Docket Item # 5 & 6  
BAR CASE # 2012-0404 &  
2012-0405

**ISSUE:** Permit to Demolish &  
Certificate of Appropriateness

**APPLICANT:** Brandon and Alice Patty by Katie Moore, Olios Design, LLC

**LOCATION:** 1107 Duke Street

**1** FRONT EXTERIOR ELEVATION  
SCALE: 1/4" = 1'-0"

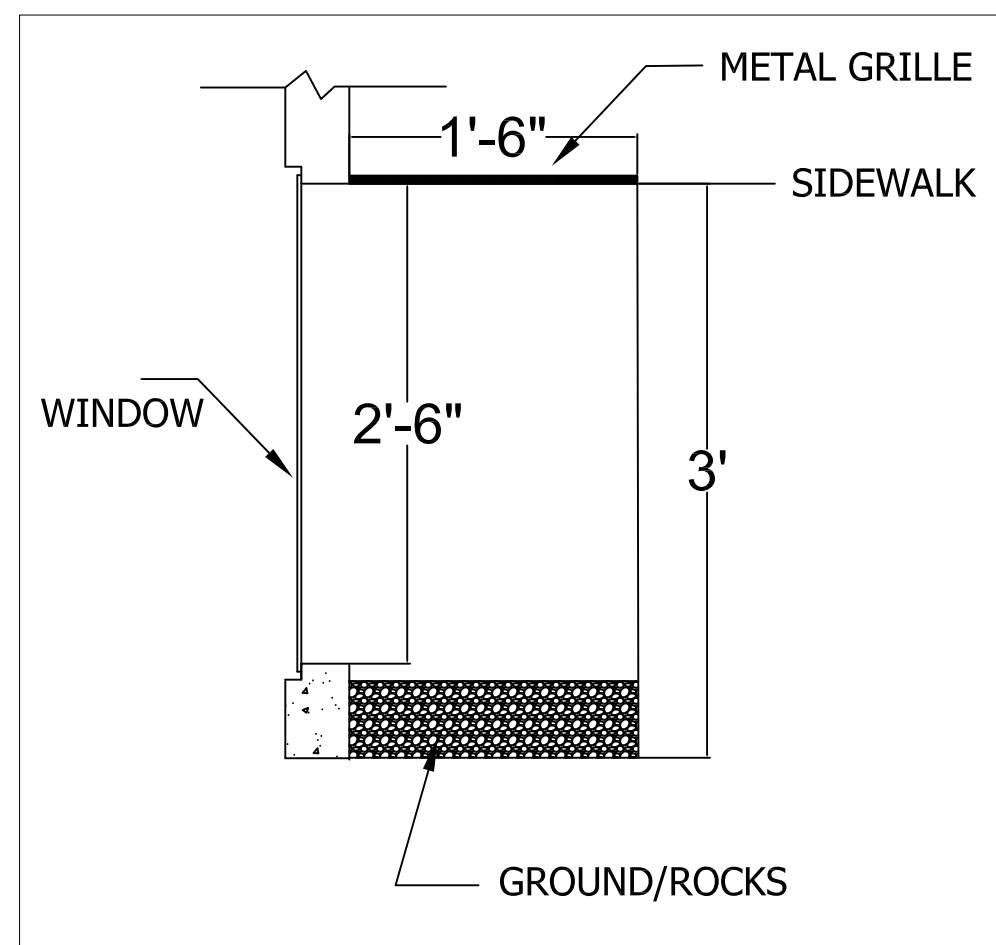
Staff supports the demolition of the front planter and the re-opening and restoration of the basement window on the front elevation. The planter is likely a 20<sup>th</sup> century alteration and its removal, combined with the reopening of the basement window, is an encouraged and historically appropriate alteration. It is evident that the house was likely constructed with a paired basement window without the existing planter, as the segmented brick arch and mullion still remain and the infill brick is noticeably different in texture than the surrounding masonry. However, the window should be historically appropriate in its dimensions and proportions.

The applicant is requesting to install a pair of one-over-one double-hung basement windows which is not a traditional basement window type. Due to the window's at- and below-grade location, the applicant also requests approval to install fiberglass windows. Staff recommends that the applicant install two wood basement windows, either casement, hopper, or awning in operation, as opposed to the proposed double hung windows. Staff cannot support a fiberglass window in this highly visible location on the front elevation due to the age of the building. Staff recommends that the applicant submit revised window specifications for the basement window for a more stylistically and materially appropriate window for staff approval before installation.

The proposed painted wood two-over-two, simulated divided light sash replacements for the remaining openings nearly meet the criteria set forth in the Board of Architectural Review *Window Policy* and will greatly enhance the historic character of the building. With a few minor changes, Staff could approve the replacement windows administratively. For example it is noted that the windows must be sash replacement kits or full-frame replacements and not insert windows. The muntins will need to have a putty glazed profile as opposed to the proposed ovolo style. It is Staff's preference and recommendation that all historic window trim and frames should be retained. The applicant should work with Staff on the details of the frame and muntins for the proposed windows before final approval.

The proposed four-panel wood door is historically appropriate and meets the requirements set forth in the Board's adopted *Policies for Minor Architectural Elements*. The proposed railing does not meet the aforementioned policy. The proposed railing should be simplistic in design and detract as minimally as possible from the prevailing Victorian style of the building. Therefore Staff recommends that the railing design have no balustrade.

The proposed light fixtures are appropriate in scale and material. Staff has no objection to the installation of a gas lamp in place of the existing electric light on the front elevation.

1. That the applicant submit revised window specifications in conformance with the BAR's adopted *Window Policy* for the proposed windows on the south elevation prior to issuance of a building permit;
2. That the proposed railing for the front stoop be a simple metal railing with no pickets; and
3. That final approval of the proposed metal grate be approved by BAR staff prior to issuance of a building permit.

**2** FRONT WINDOW WELL SECTION  
SCALE: 1" = 1'-0"

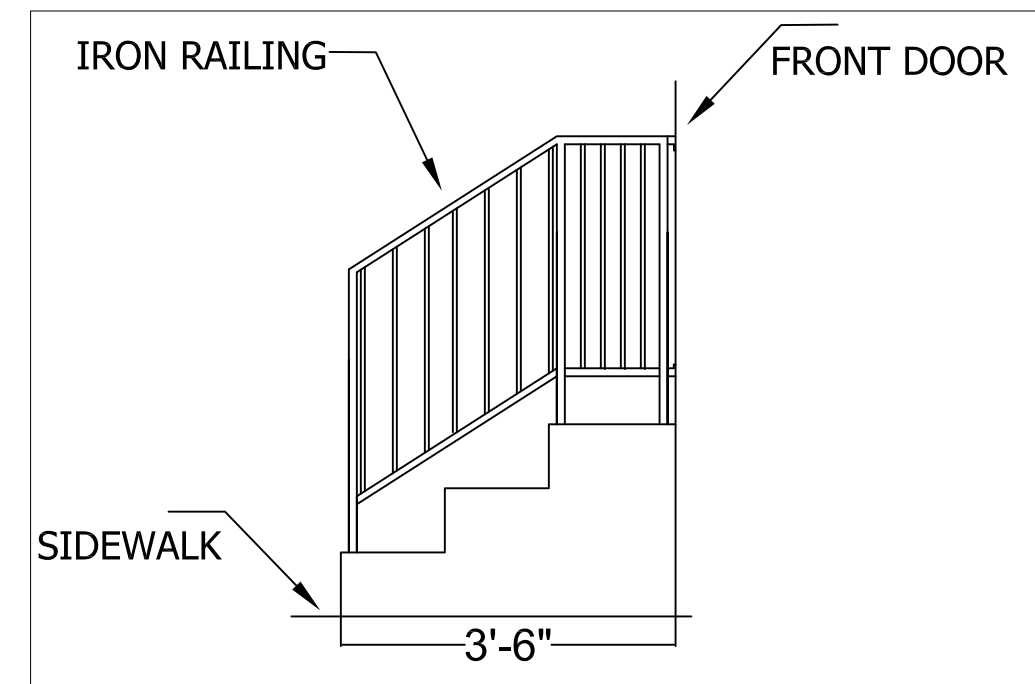
The proposed window well complies with Zoning, if the window well projects into the public right-of-way, the applicant must apply for an encroachment. Staff has no objection to the proposed window well as window wells are a common feature within Alexandria's historic districts. However, the applicant will need to submit specifications to Staff for the proposed metal grate prior to installation.

- F1. Per the plat that was received on January 7, 2013, it is shown to remain behind the property line; hence no Encroachment will be required at this time. An Encroachment (Public Right-of-Way) will be required for the front Window Well if it is discovered to extend beyond 4 inches from the property line during future permit and/or plan submissions. (Sec. 5-2-29) (T&ES)

**1** REAR EXTERIOR ELEVATION  
SCALE: 1/4" = 1'-0"

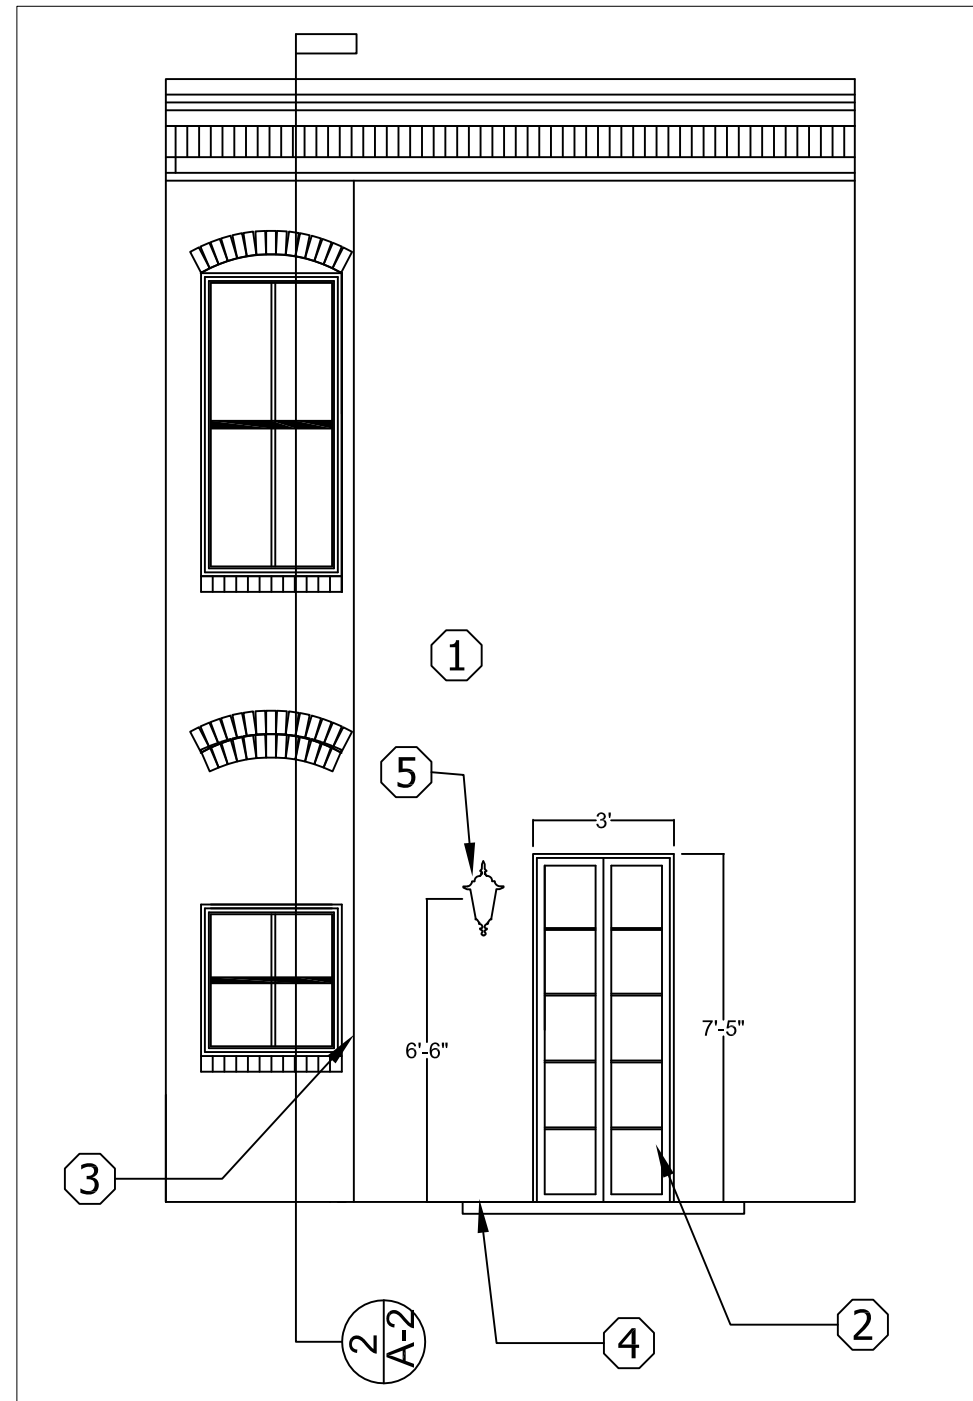
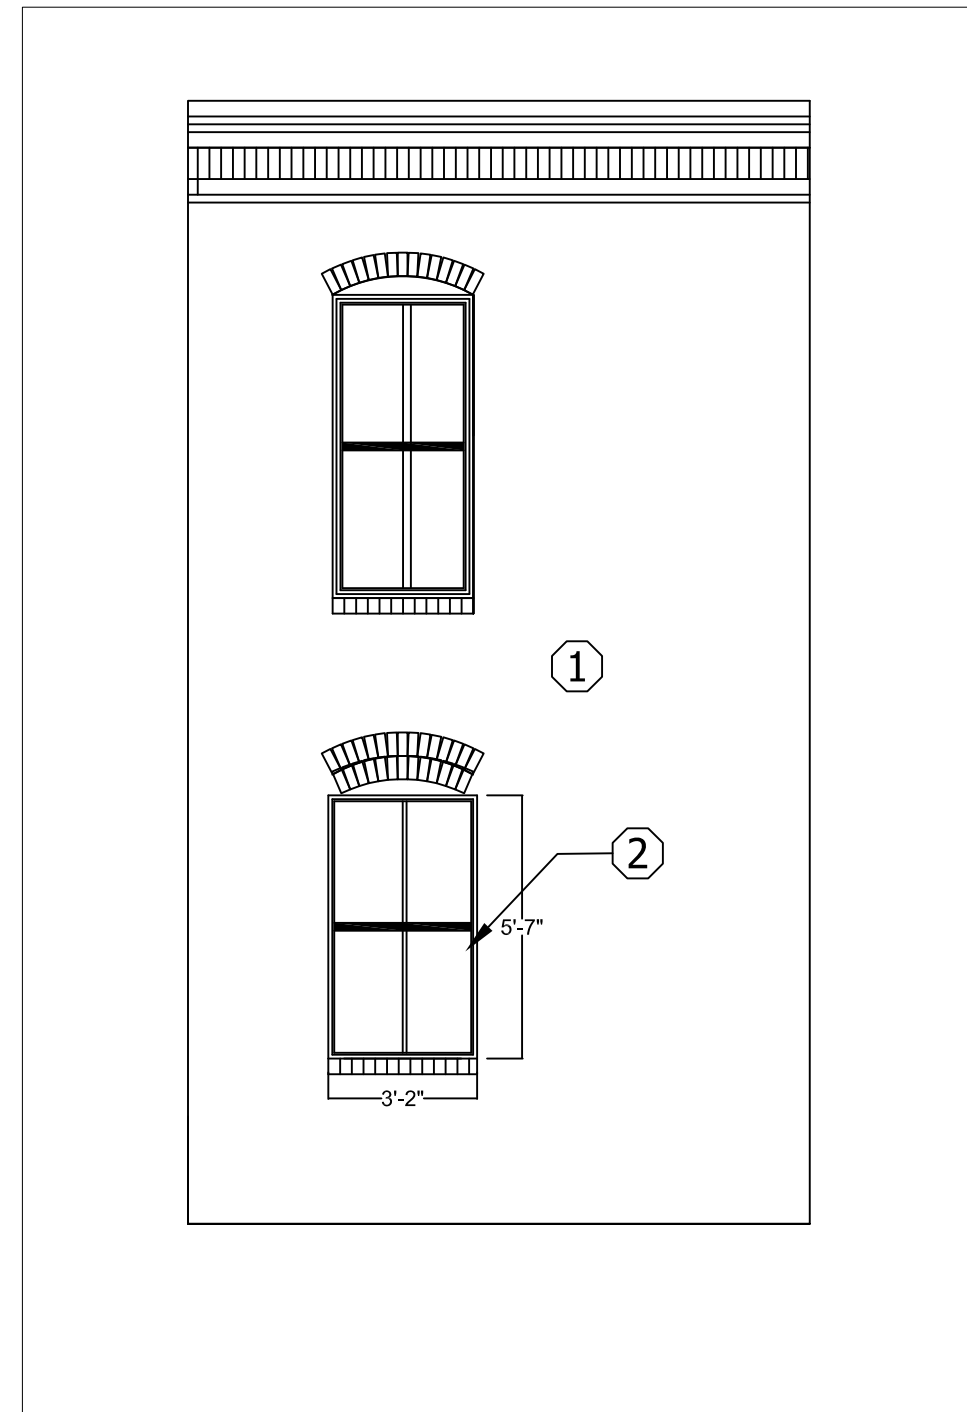
The north elevation does not have the same level of integrity as the front elevation. On the north elevation of the rear ell, two second story windows have been removed and replaced with brick, discernible by the disruption in the seven-course common bond brick pattern, and the first story window on this elevation has been considerably reduced in size. Remaining windows have been replaced with six-over-six vinyl windows. Staff fully supports the applicant's proposal to replace the historically inappropriate vinyl windows with wood simulated divided light two-over-two windows, as this complies with the adopted *BAR Window Policy*. The historic window frames should be retained where possible.

Staff has no objections to the design of the French doors, proposed Bevolo electric light fixture, or proposed rear at-grade wood deck as these elements are minimally, or not at all, visible due to an existing rear-yard fence.

The replacement of an existing door and transom on the east elevation of the rear ell with a window is also supported by Staff. The opening may be original to the building however the existing door is not. There have been numerous alterations to openings on the rear ell over time that have lessened its integrity. Staff notes that this change is minimally visible from a public right-of-way and is a common alteration to rear ells as buildings are adapted for modern use.
